CITY OF FRANKLIN

REPORT TO THE PLAN COMMISSION

**Planned Development District No. 37 Amendment
and Comprehensive Master Plan Amendment**

Project Name:	The Rock Sports Complex/Ballpark Commons PDD No. 37 Amendment and CMP Amendment
Project Address:	7900 W. Crystal Ridge Drive and vicinity
Applicants:	Michael Zimmerman, Greg Marso, Zim-Mar Properties LLC, and John Dargle, Jr., Director, Milwaukee County, Department of Parks
Property Owners:	Milwaukee County, Wisconsin Department of Transportation, Zim-Mar Properties LLC, FF & E LLC, Frank & Sally Stanzer, Bradley Savage
Current Zoning:	PDD No. 37, FW Floodway District, and R-3E Suburban/Estate Single-Family Residence District
2025 Comprehensive Plan:	Mixed Use, Areas of Natural Resource Features, Residential Use, and Transportation Use
Use of Surrounding Properties:	Root River Parkway (Village of Greendale) to the north, S. 76 th Street and single-family residential to the east, Loomis Road (State Highway 36) to the south, and single-family residential to the west.
Applicant's Action Requested:	Recommendation to the Common Council for approval of the proposed Planned Development District and Comprehensive Master Plan amendments.

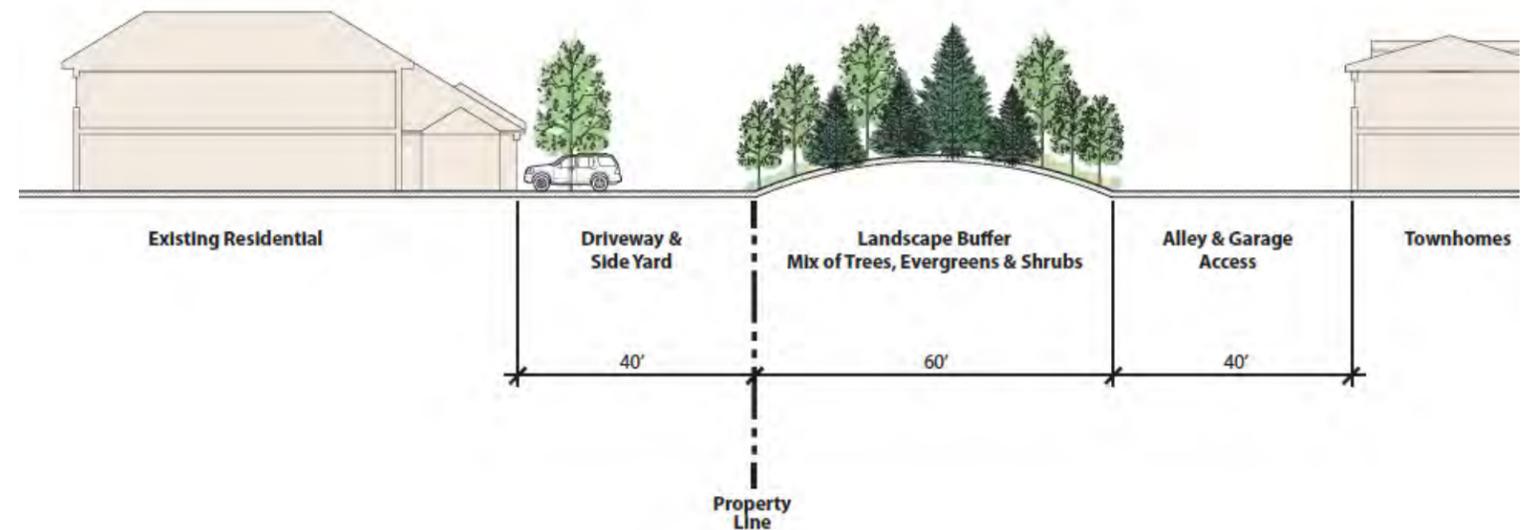
The vegetative buffer proposed by the applicants indicates a 60' wide landscaped area with a 8' high berm, and an additional 40' building setback. As such, staff recommends that the requested General Landscape Plan, and the pertinent zoning district standards, be revised to reflect a minimum 60' wide landscape buffer, including a minimum 8' high berm, to be located along the entire western boundary of PDD No. 37, for staff review, prior to the submittal of any detailed plans within PDD No. 37. Staff further recommends that the applicable zoning district standards be revised to reflect a 40' building setback from the western boundary of PDD No. 37.
